SERVICE BULLETIN: JSB 033-2

Subject: Piston Circlips

Affected Models: Jabiru 2200 and 3300 Engines

Figure 1 – Type A (Left) & Type B (Right) Circlips¹

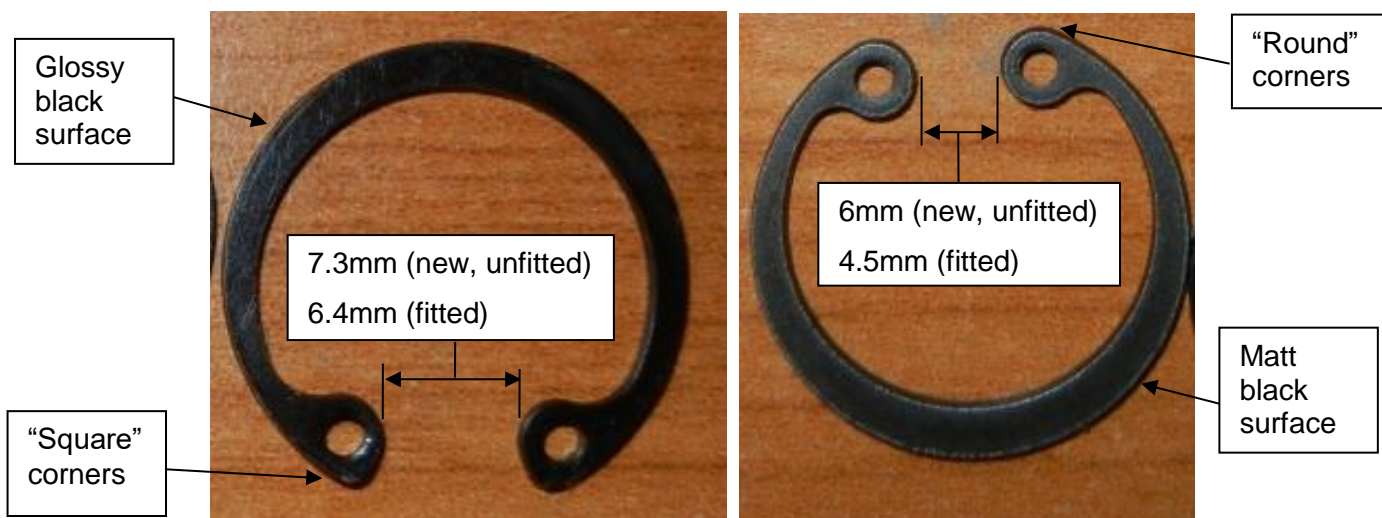
- 23mm Circlip is Jabiru P/No. PH0545N.

- Disassemble the engine and replace the 23mm circlips, pistons and gudgeon pins with current parts.
- **OR** Return the engine to Jabiru Aircraft or our local authorized representative for correction.

Figure 2 – Clip Installation Details

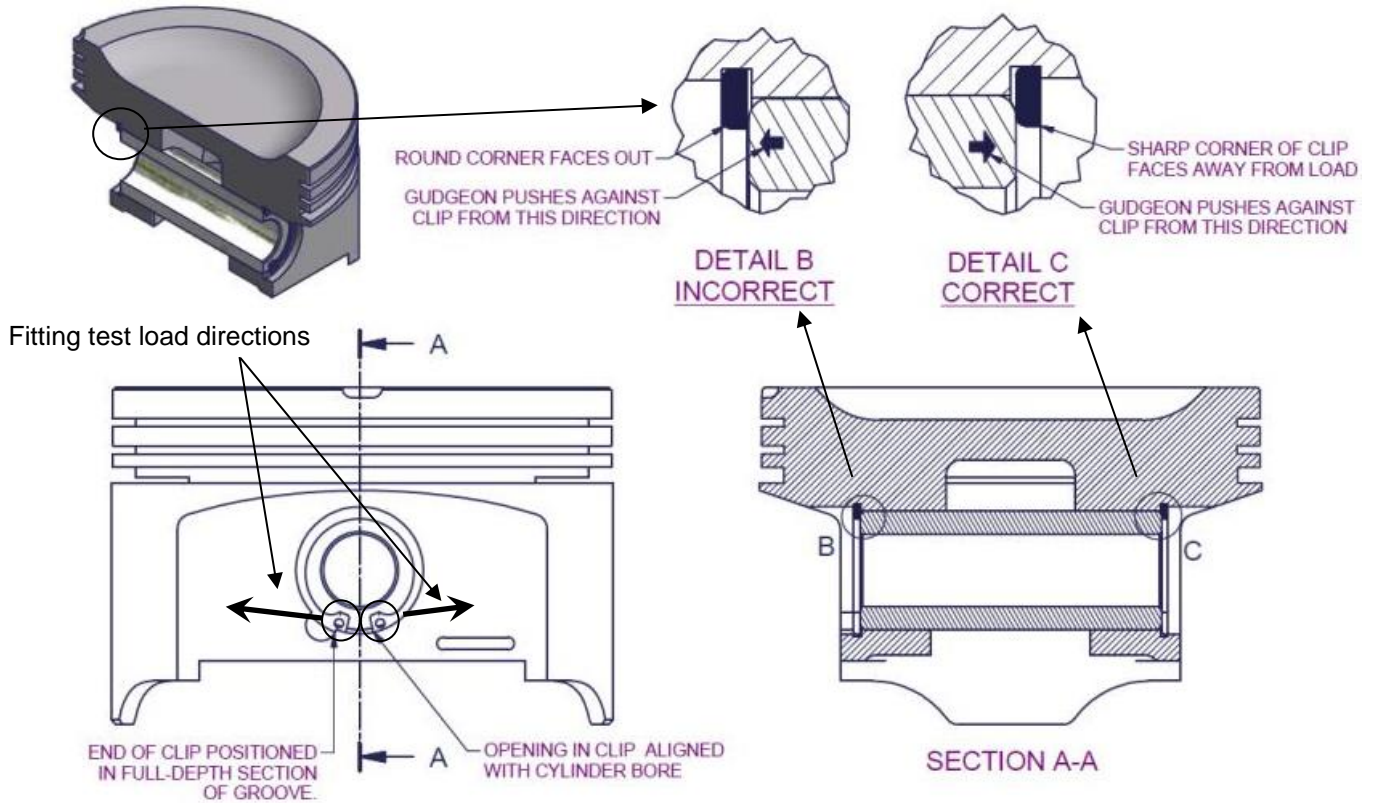
- Clips must be oriented correctly on installation: See Figure 2: the clips must be fitted with the sharp-edged corner facing outwards.
- When installing clips compress them by the minimum amount required for fitting. DO NOT compress them until the eyes of the clip touch.
- Ensure the clip clips into the groove properly: there should be a crisp "click" as the clip fits into place. Visually and using a small screwdriver or pick, check that the clip is sitting evenly in the groove.
- Ensure that the opening in the clip is oriented as shown in Figure 2: it must face along the axis of the barrel.
- Ensure that the ends of the clip are both positioned within full-depth sections of the groove as shown in Figure 2.
- After fitting use a small screwdriver or pick to apply pressure to the clip as shown in Figure 2: the clip should not rotate. If the clip moves, discard it and fit a replacement.

Figure 3 – Worn Circlip Grooves.

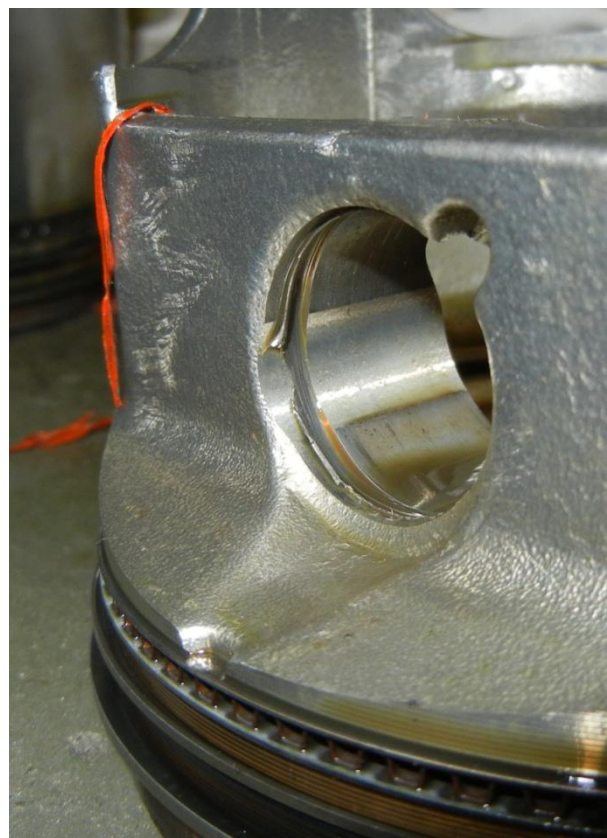
- Thoroughly inspect the pistons for damage or wear to the circlip groove. If wear or damage is noted contact Jabiru Aircraft for additional guidance.
- **OR** Return the engine to Jabiru Aircraft or our local authorized representative for correction.
